ESTERO COMMUNITY PLANNING PANEL

Minutes of Public Meeting #163 – July 21, 2014 Estero Community Park, Estero, Florida

ILLUSTRATIVE PROPOSED MASTER PLAN
JOB# 5217

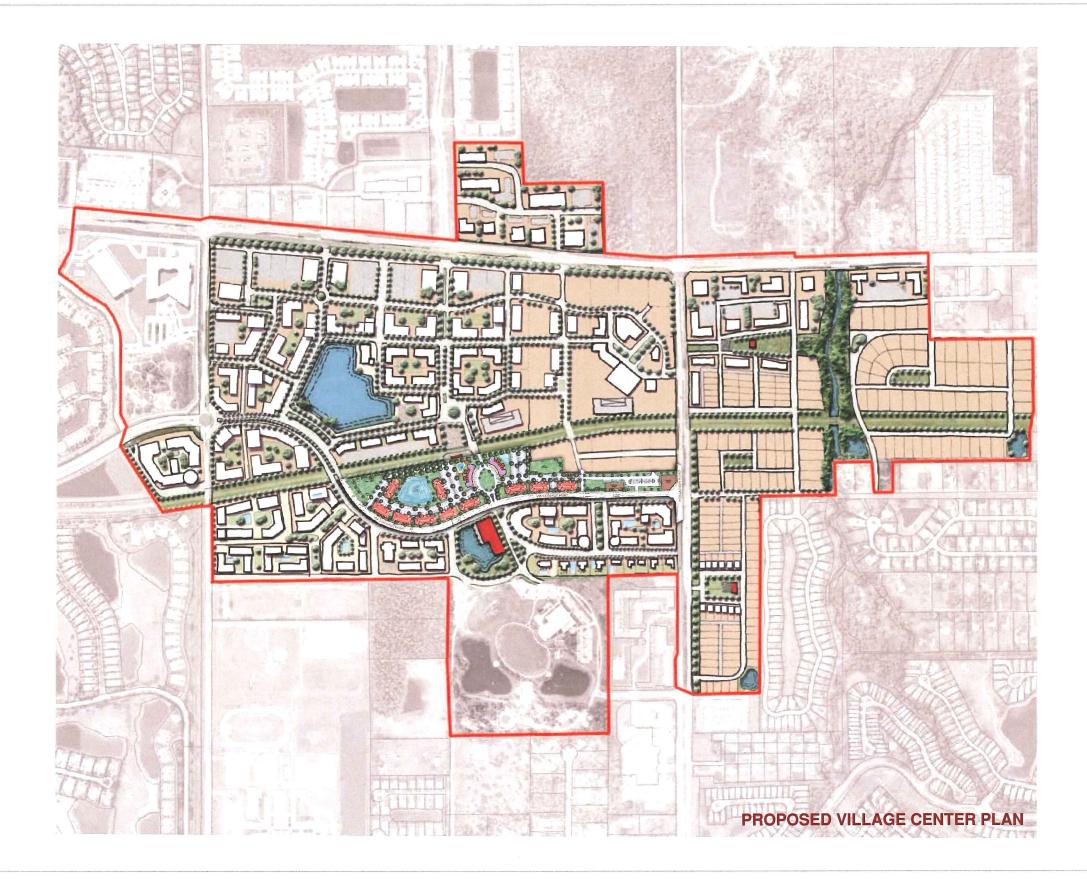
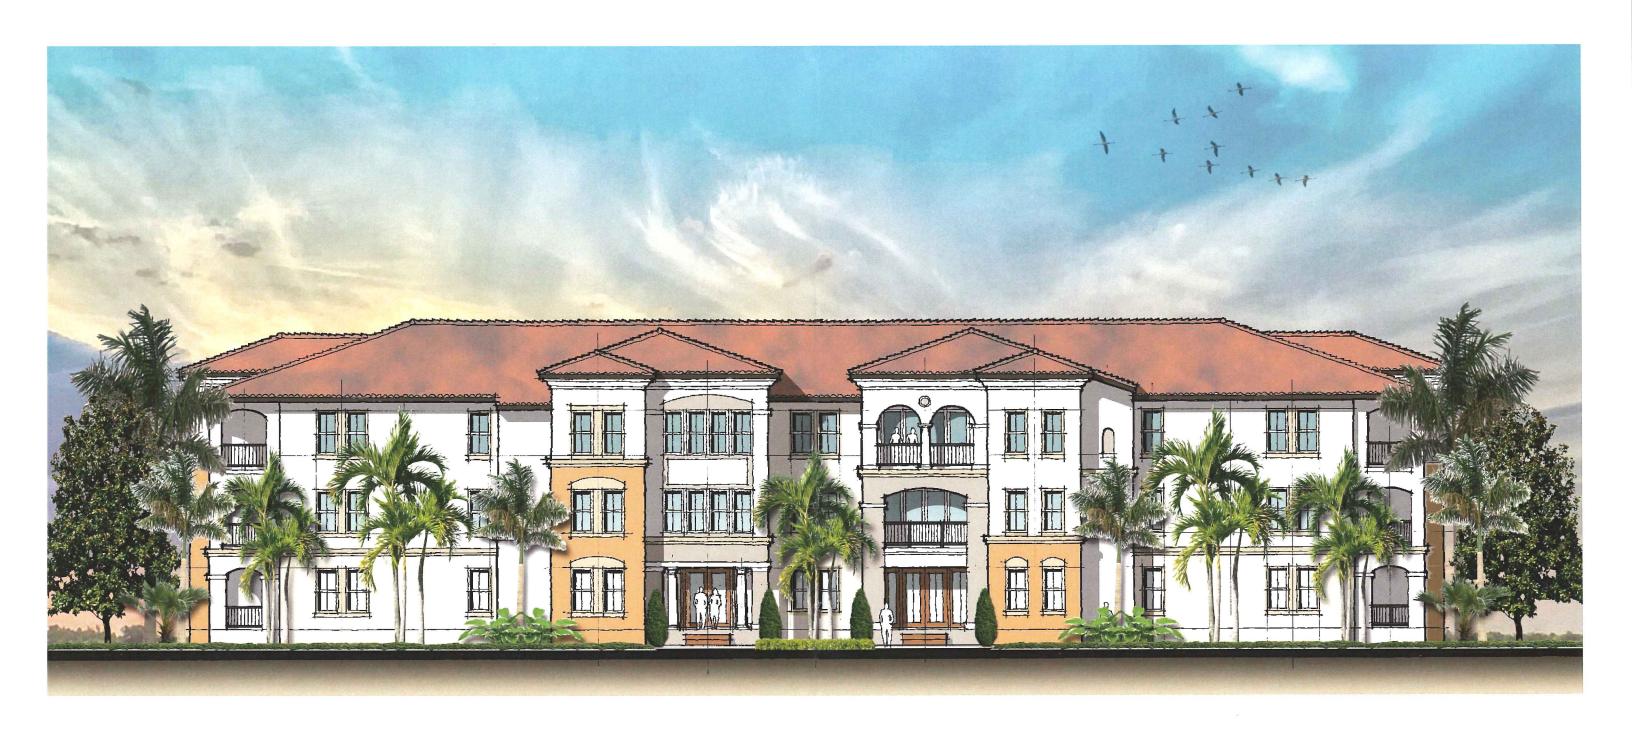
Comments of the Panel. Chairman Lienesch started off by discussing the fact that there is no perceived tie in between the commercial and the residential uses. Ned Dewhirst agreed and said that they will have a real challenge convincing the Panel that they have a true "super" mixed use development to qualify for the higher density calculation over the entire site. At 21 units per acre over 15 acres, Dewhirst commented that we are likely talking about 5-6 stories of height. Dewhirst feels that the appropriateness of the higher density residential project may not be the issue since this is a very challenged site dimensionally and generally isolated by the railroad

ROW and Via Coconut Road; therefore the proposed residential use is likely appropriate for this property. The Lee Plan FLUM and Land Use amendments are supposedly going to the LPA this month, but it is not clear when or if these new provisions of the Comp Plan will be completed. Greg Toth disclosed that he is currently an owner of this property. He had originally participated in the Seth Harry Study to study whether this property might be useable to create a walkable, compact neighborhood in Estero.

Hartsell then asked the Panel as to whether or not we really want to see higher densities in this area, and if so, this would be a good opportunity as to how we could get there. He went on to state that the Developer is still only talking about garden-type apartments which would not need a deviation from the 45' foot height limitation. The issue boils down to whether or not the density uses the higher counting method of the mixed-use developments. e.g. 330 vs. 280 depending on whether it qualifies for the super calculation of the mixed-use categories. They have to do a text amendment to create a special Urban Places category (rather than use the current Intensive Development category of the FLUM). They would also be doing the re-zoning at the same time. Ned Dewhirst stated that we have not even discussed compatibility with the Happy Hollow homes. He also commented that the southern access on the plan would be a right out right in, and may only be used on an emergency basis. The railroad was and is a barrier which will have to be dealt with. The existing railroad crossing on Via Coconut cost the developers of Coconut Point over \$1.5 MM including the insurance for the location. Dewhirst suggested that since the proposed commercial area is dimensionally challenged in addition to possible compatibility issues with the adjacent SF, the applicant should consider making this area OS/SWM and would then qualify as part of the residential area which would contribute towards the desired density calculation. If the neighboring SF land use were to change in the future, then this part of the project could be reevaluated at that time.
